City of Bristol
Planning Commission

REGULAR MEETING - MONDAY, MARCH 24, 2025
CITY HALL COUNCIL CHAMBERS
111 NORTH MAIN STREET
6:00 P.M.

CITY OF BRISTOL
SITE PLAN REVIEW COMMITTEE
STAFF COMMENTS - 438

CITY OF BRISTOL
SITE PLAN REVIEW COMMITTEE
STAFF COMMENTS - 436

DRAWING NO.
PLN-002
SHEET NO.
5

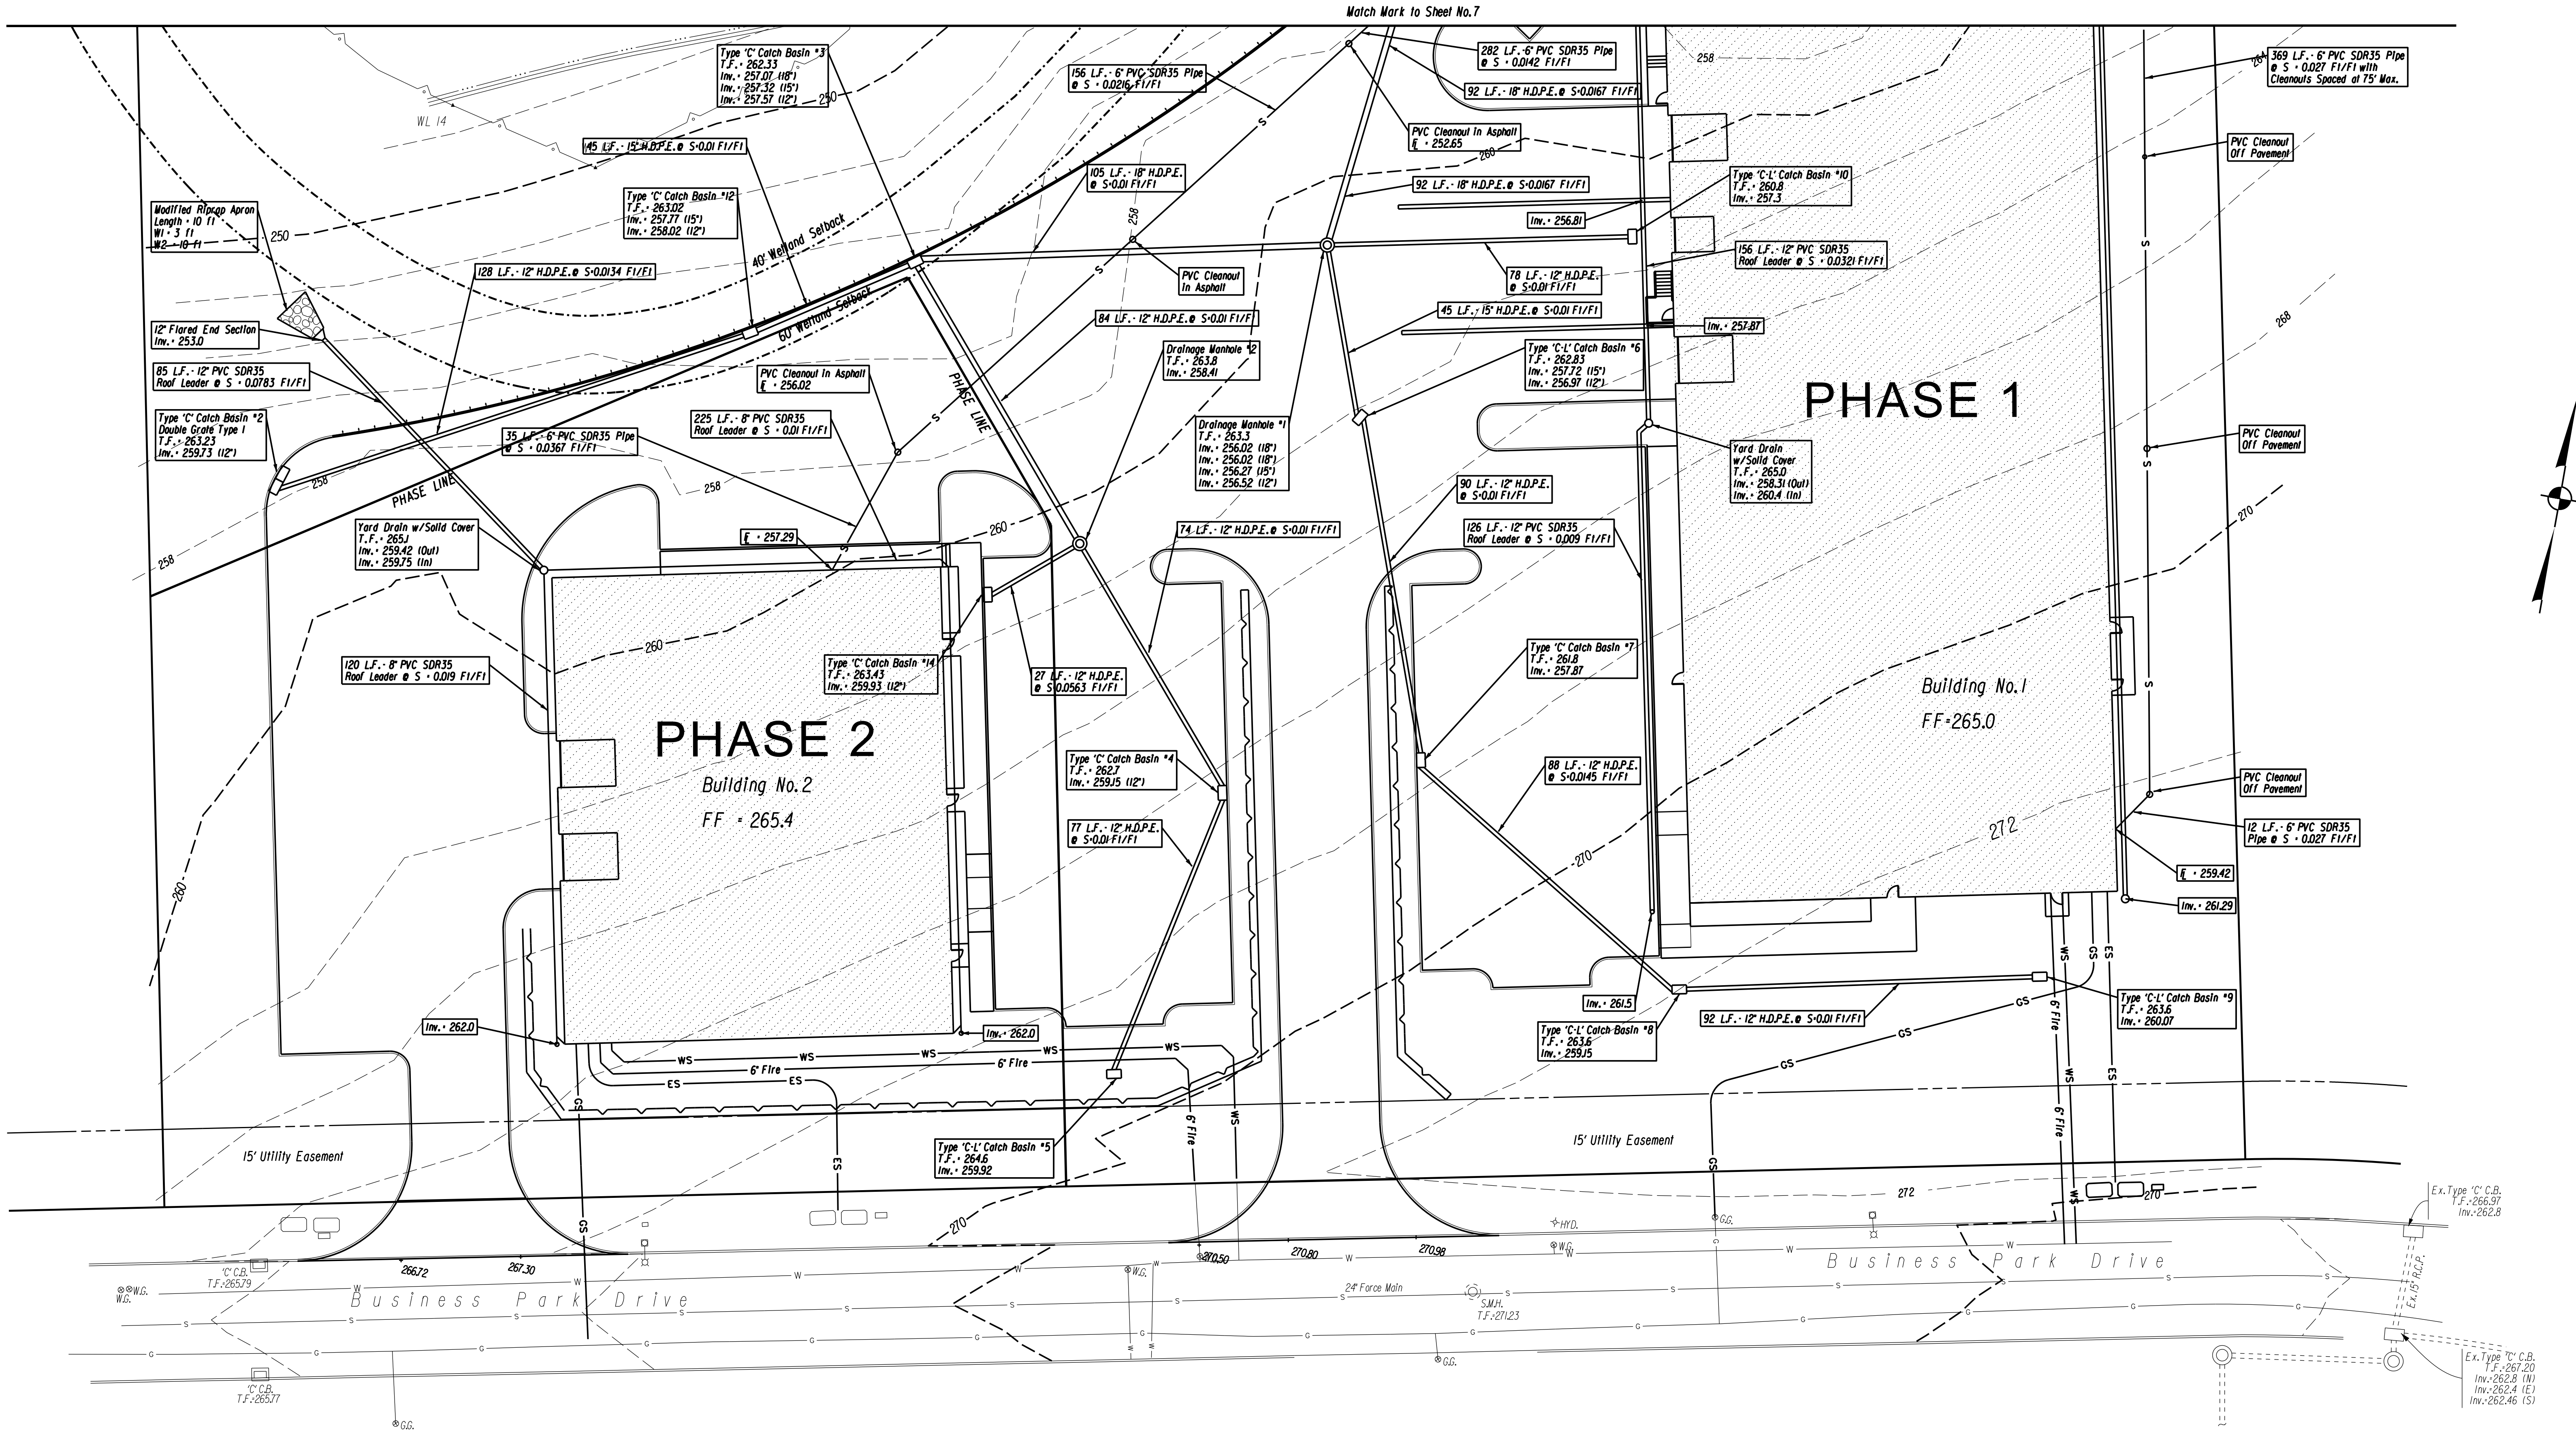
7. There are notes on the plans showing tree removal along the property lines that appear to be on the adjoining lot. Is an easement provided for this work? What is the limit of the work?

6. Does Phase 1 and 2 buildings contain loading docks? If so, please provide details, label on the plan and provide hatching areas where loading would occur. See off-street loading requirements - Article III, Section 13.10.

3/1/25 Applicant Response: Both Buildings will have loading areas on the West Side of each building. Phase I contains 1 loading dock and 2 back in loading bays. Phase 2 will have a loading area however at this time it is undetermined whether it will be a loading dock or back in bay.

3/1/25 Applicant Response: Done. See sheet 4.

ASSESSOR'S MAP/LOT:	3 / 3	DRAWING NO	UTIL-002
DRAWING TITLE:	DRAINAGE AND UTILITIES	SHEET NO.	7

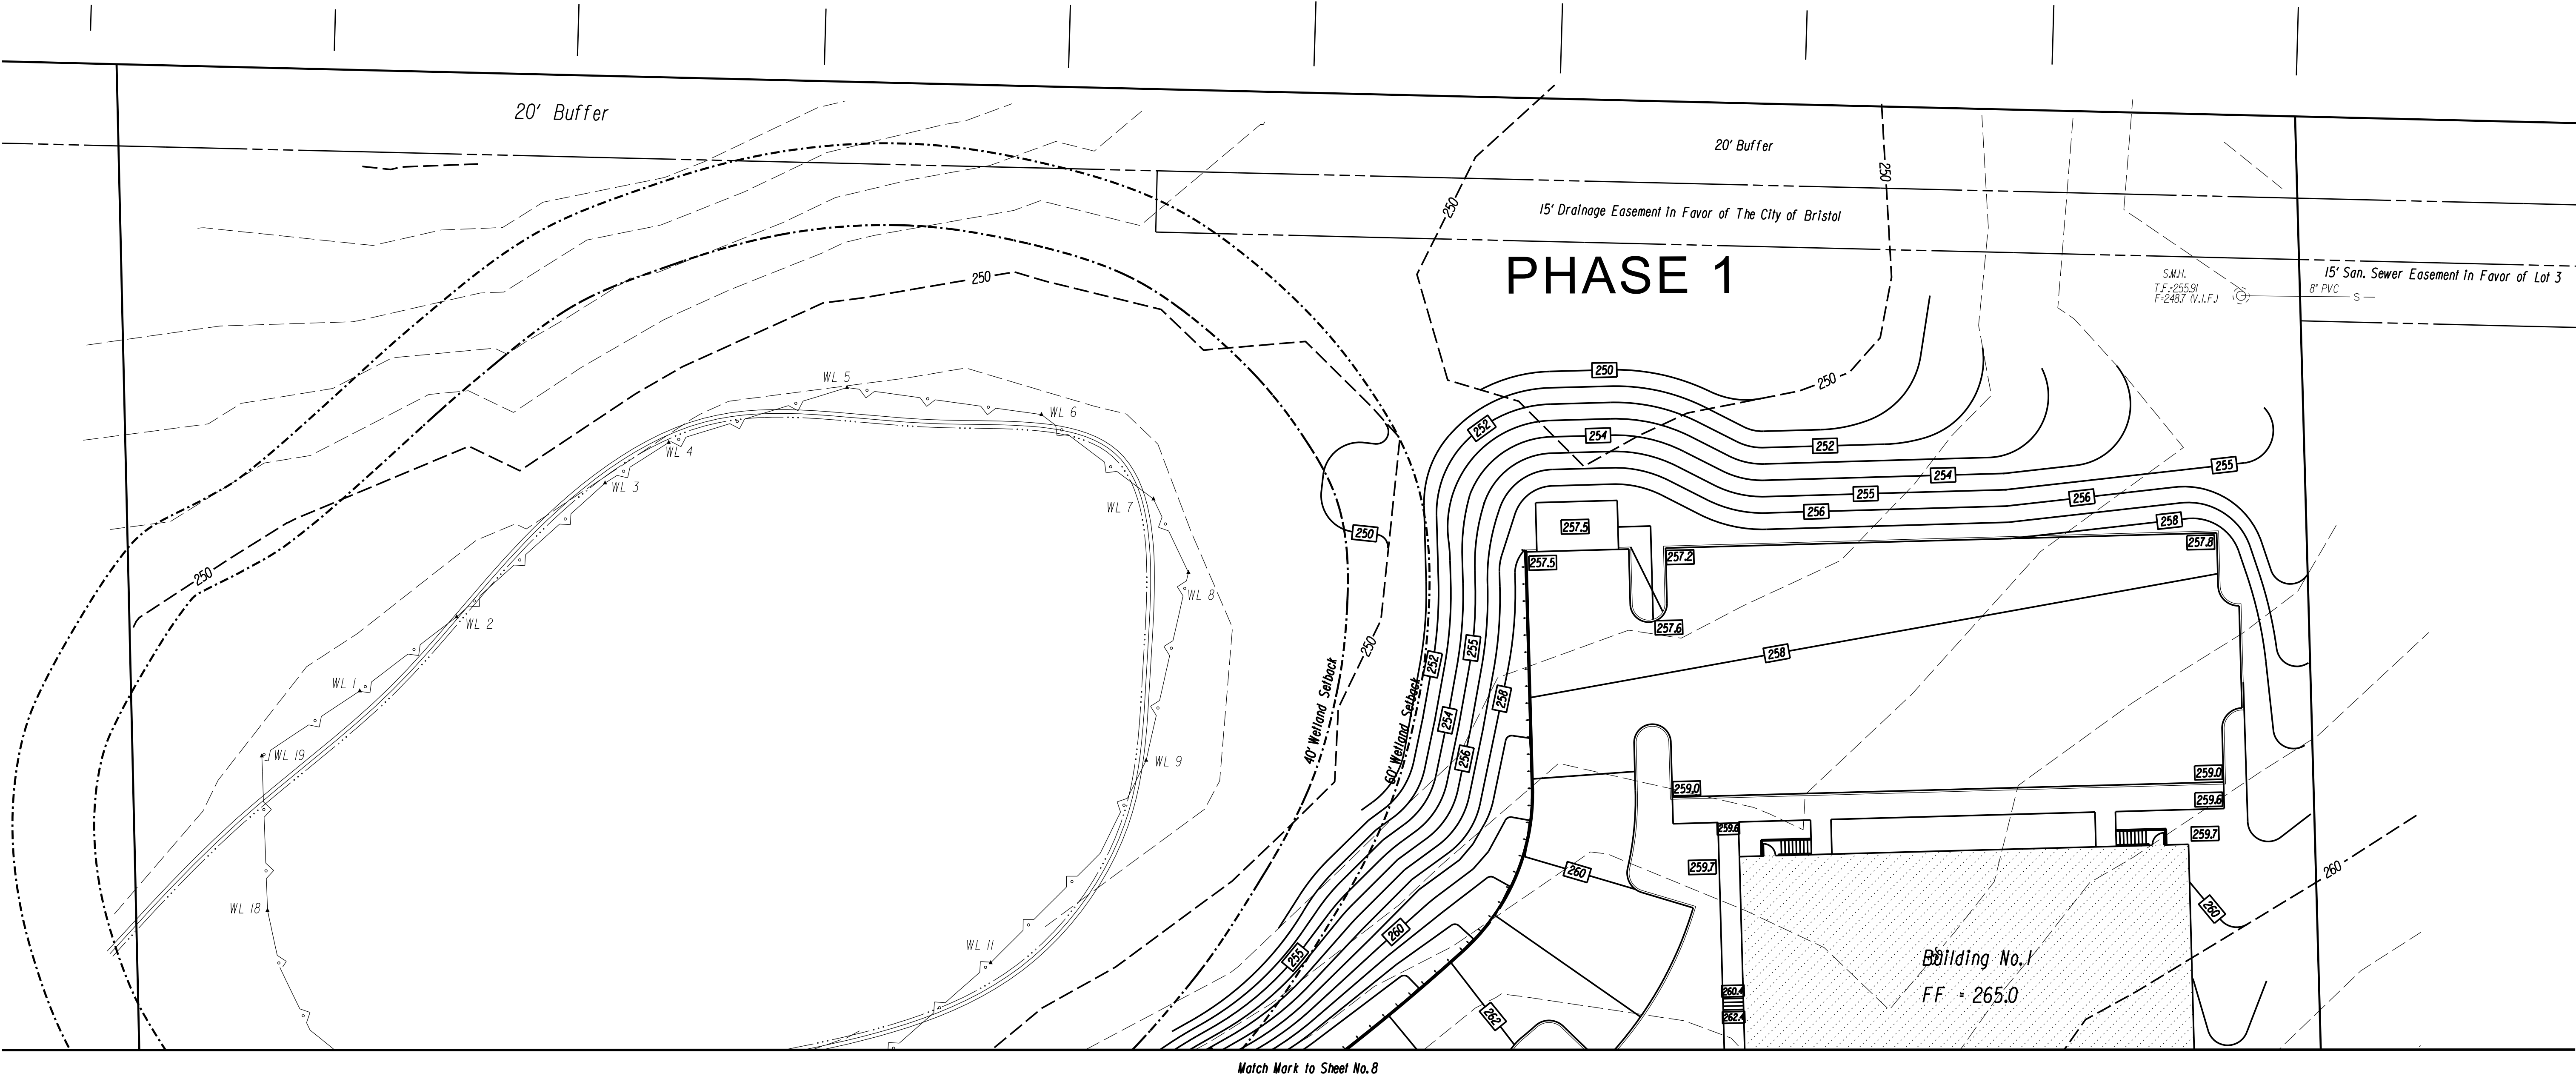
5. The drainage design does not provide any sub surface detention and is using the on-site wetlands as a detention area. Can the applicant provide a surface water elevation for the various storm events 2-100 year?

3/1/25 Applicant Response: The storage volume available was assessed as plans were being developed. The approval of the original Business Park Plans allocated up to 140,000 cubic feet of stormwater storage from Lots 3 and 4 into the subject wetland area. No runoff was directed to the wetland from Lot 4 as its plans were developed and constructed. The runoff from Lot 3 to the wetland for the 100-year event amounts to 126,000 c.f. The volume of the wetland area was computed and the runoff from Lot 3 was modeled using Hydrology Studio software. The wetland is bounded by an earthen berm whose top elevation is just over 250. The model analysis assumed that there is no exfiltration during the storm event and the expected elevation for the 100-year event is 249.26. The assumed surface of the wetland is 248 (bottom of the storage basin). The surface area at elevation 250 is 1.3 acres. The expected elevations in the wetland is as follows: 2-yr event - 248.24, 25-yr event – 248.87, and for a 100-yr event – 249.26.

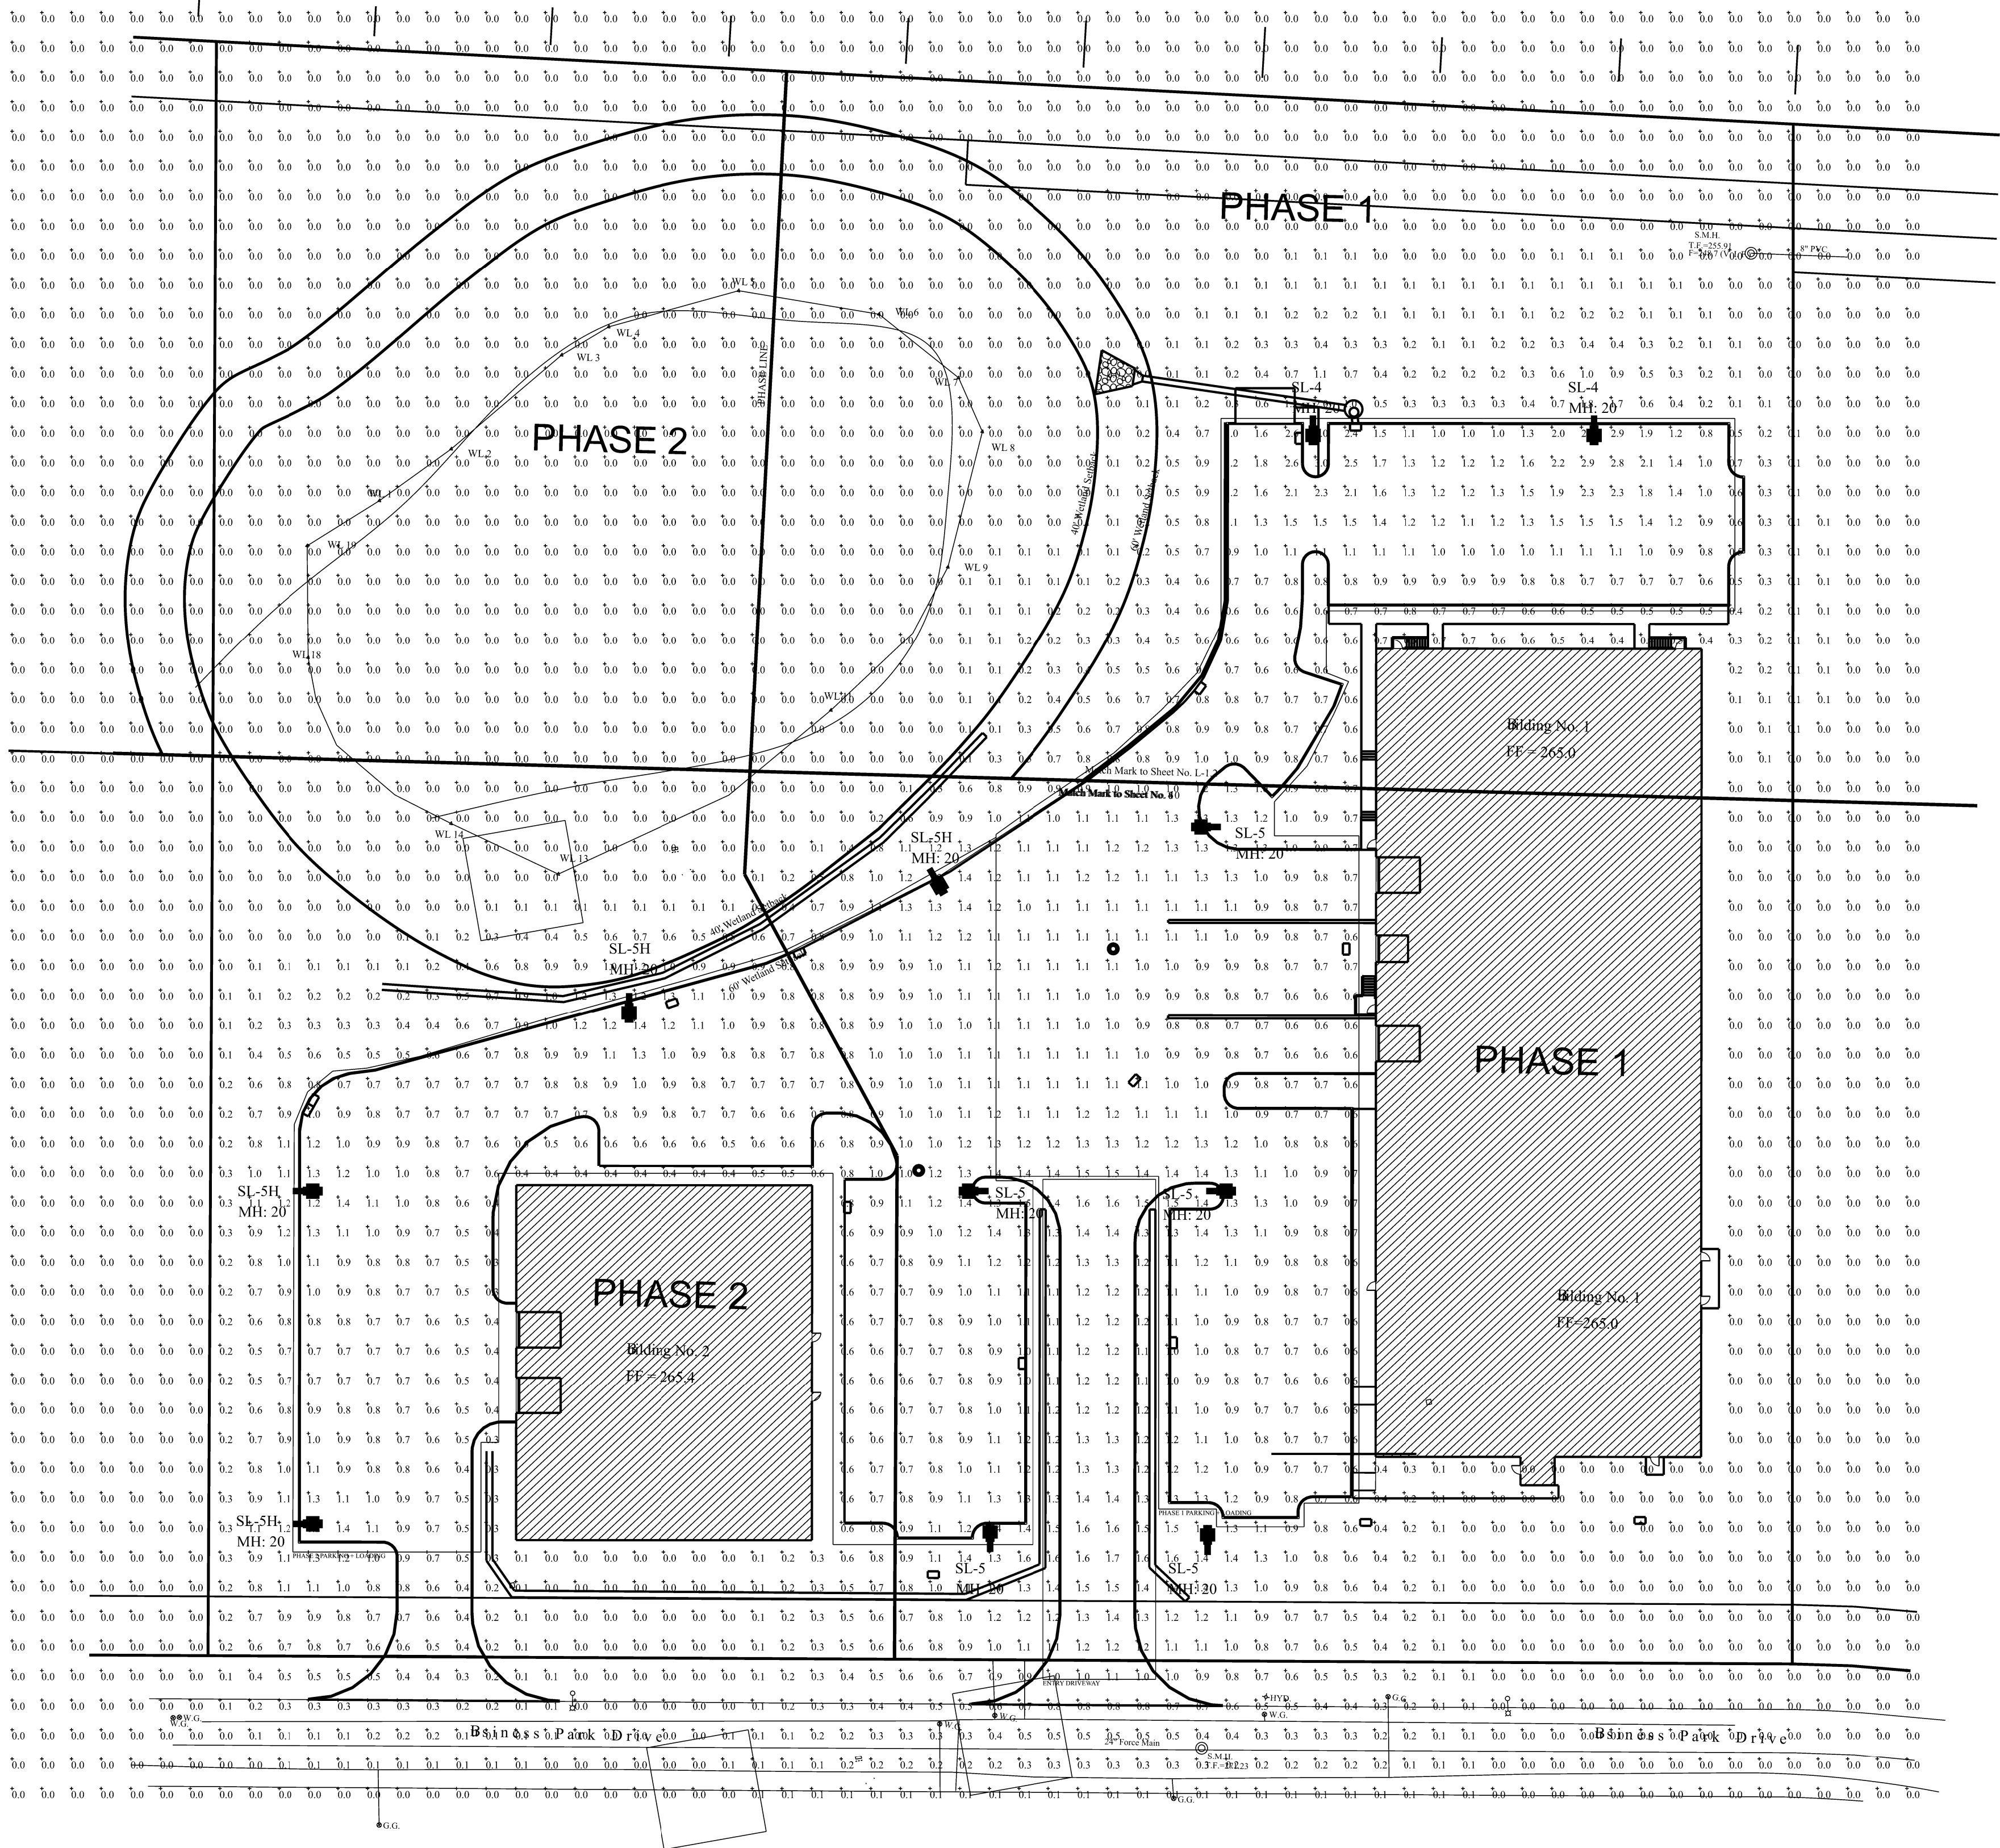
8. Clarify landscape plantings size. Provide height in feet.
